Tri-Cities Crossing Preliminary Zoning Development Plan/B-4P

Planner:	Ken Weems	Date:	March 28, 2024
Planning Commission Action		Meeting Date:	April 26, 2024
Approval:			
Denial:		Reason for Denial:	
Deferred:		Reason for Deferral:

To receive Gateway approval in a B-4P zone for a new Southern Tire Mart.

Architectural Design

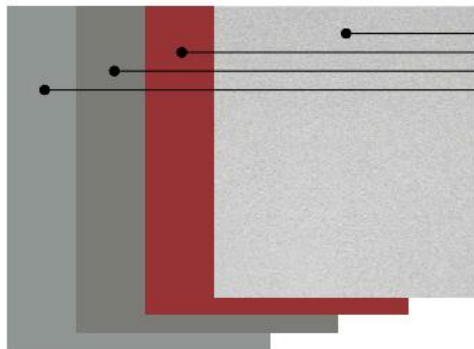
The building is clad in metal panels. Per gateway standards this material for cladding is required to have a waiver.

Sign Details (Freestanding)

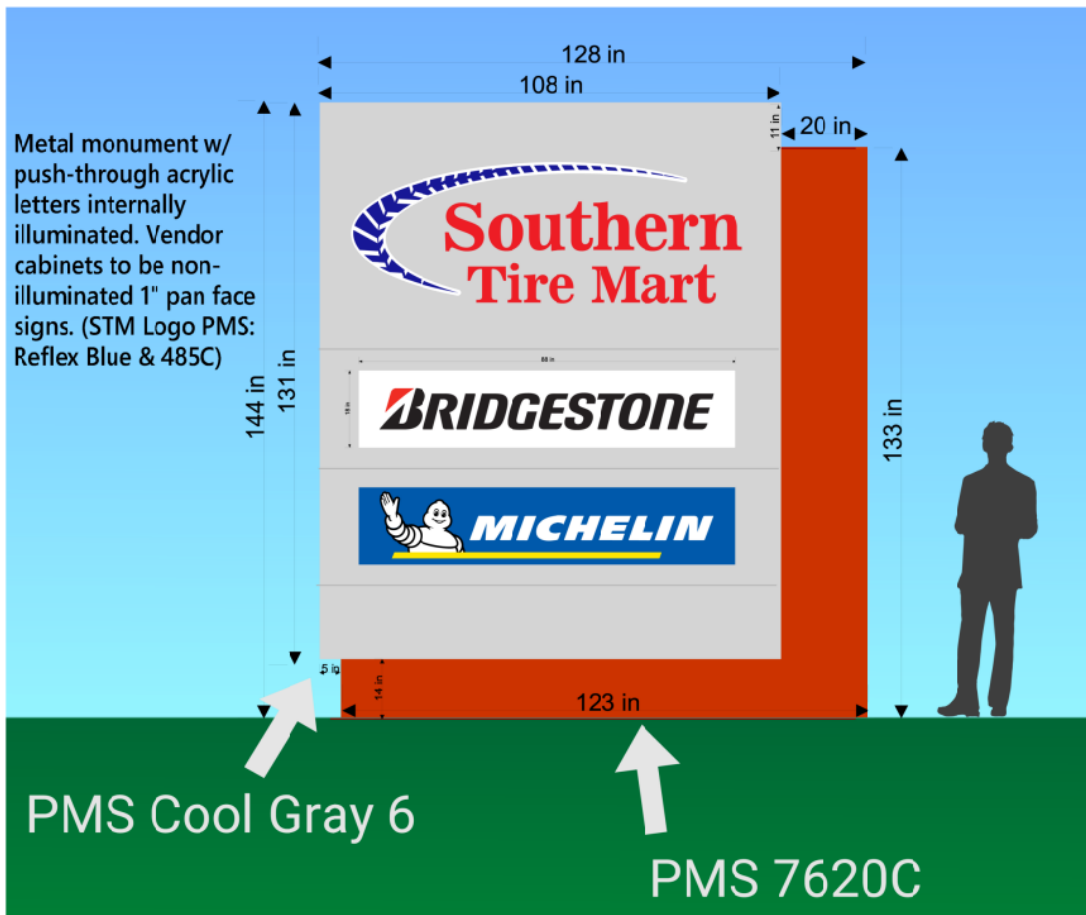
The freestanding sign is allowed to be up to 100 sq ft in size (this is the allowance after being reduced by the Gateway 50%). The proposal contains a grey colored area with sign copy that is 99.75 sq ft. The applicant has proposed the red portion of the sign to account for the monument sign base and sign frame cover, thus not counting the red to the side of the grey colored part of the sign. This interpretation is debatable for the meeting. The red portion of the sign is roughly 35 sq ft.

Staff recommends discussing the freestanding sign qualities with the applicant for a common understanding and granting subsequent Gateway approval.
